PLANNING DIVISION STAFF REPORT

Project Address: 656 Williamson Street (District 6 – Alder Mayer)
Application Type: Conditional Use Alteration
Legistar File ID # [88776](#)
Prepared By: Chris Wells, Planner, Planning Division
Report Includes Comments from other City Agencies, as noted
Reviewed By: Meagan Tuttle, AICP, Planning Division Director
Kevin Firchow, AICP, Principal Planner, Planning Division

Requested Actions: Consideration of a major alteration to an approved conditional use in the Traditional Shopping Street (TSS) District to construct a five-story, 53-unit, mixed-use building at 656 Williamson Street.

Image 3: Existing Views along Sidewalks of Mid-700 Block of Jenifer Street with the existing building massing and the Capitol dome outlined in red. Left: North Sidewalk. Right: South Sidewalk

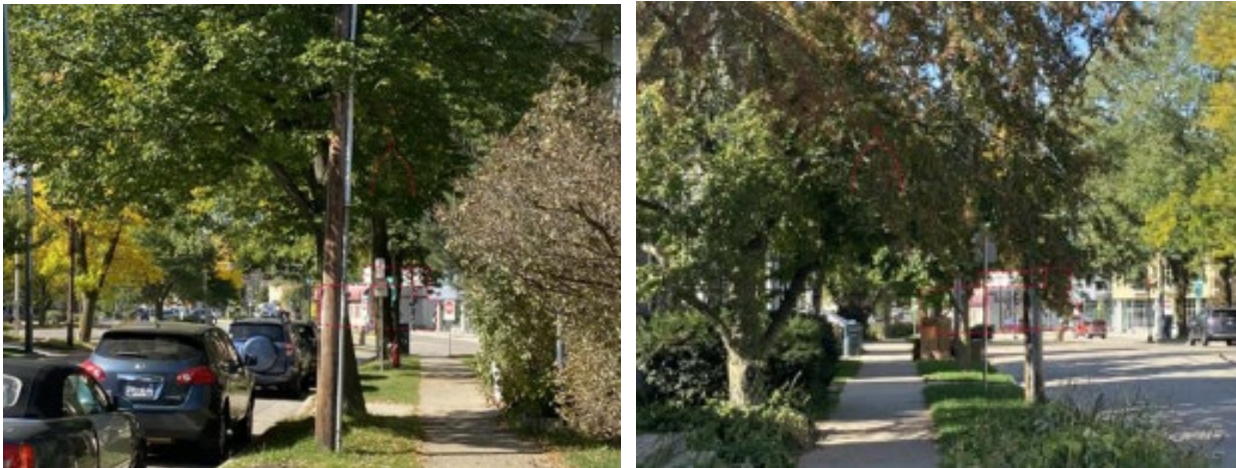
Examining the updated massing study, while further reduced with the lack of a massing setback at the fourth floor level, staff note that it is still possible to see the very top of the capitol dome from both sidewalks of the 700-block of Jenifer Street, though that comes with the large caveat that, as mentioned by the applicant, the existing street trees already significantly obscure if not completely block the view. Staff note however that the dome is slightly less obscured by seasonal tree foliage for motorists and cyclists traveling in the street. (See Images 3, 4, and 5, below)
